CITY PLANNING COMMISSION
915 "I" STREET - SACRAMENTO, CALIFORNIA 95814

- NATOMAS OAKS*
- ① BACKGROUND NEEDED*
- APPLICATION: 1. Negative Declaration with mitigating measures.
2. Amend the South Natomas Community Plan to allow back-on lots to the levee parkway.
3. Rezone 8.5+ vacant acres from Single Family R-1 to Townhouse R-1A. *which lots are R-1A - any plans*
4. Special Permit to allow single family residential units.
5. Subdivision Modification to allow lots deeper than 160 feet.
6. Tentative Map.

APPLC. NO. P-8992

MEETING DATE April 24, 1980

EXHIBIT 'E'

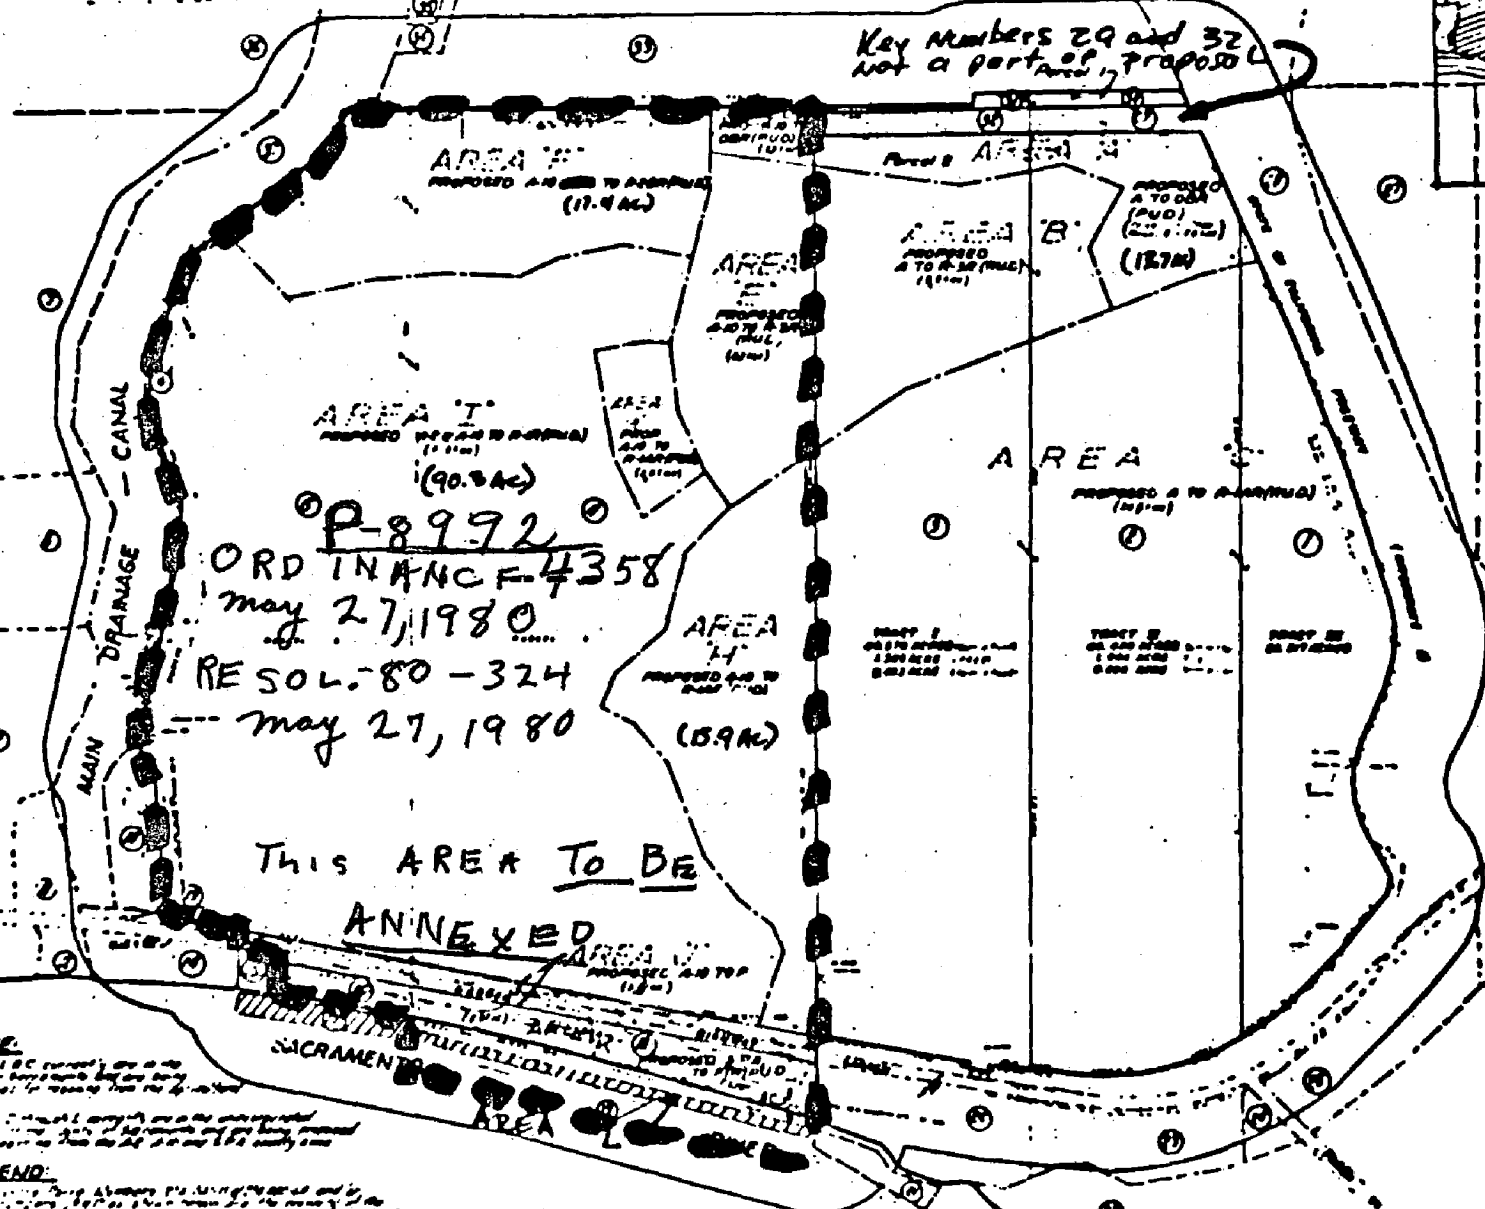
Key Numbers 29 and 32 not a part of proposal

LEGEND:
... ONLY KEY NO. 19
included in proposal

SCHEMATIC SITE PLAN

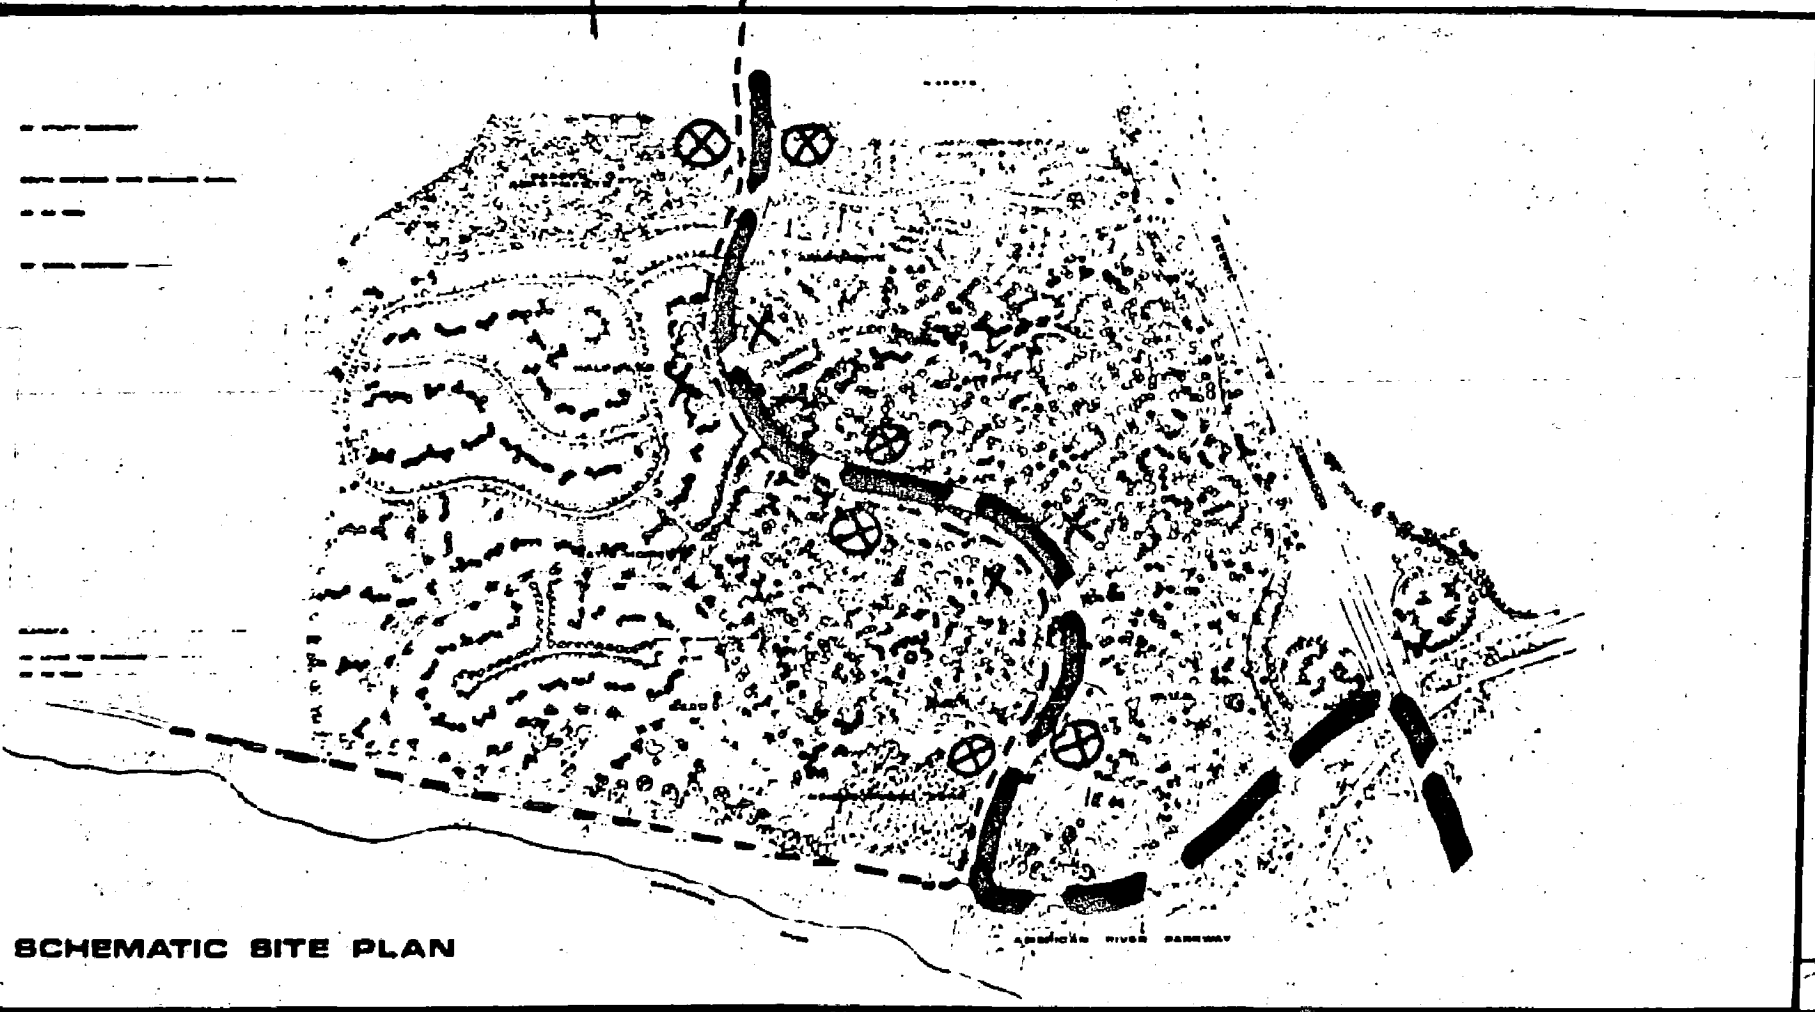
-  MAIN ROUTE
-  SHUTTLE ROUTE
-  STOPS W/ SHELTERS
-  STOPS WITHOUT SHELTERS

h. The applicant shall provide five pairs of bus stops, three pairs of which are to include bus shelters, as indicated on Exhibit C.
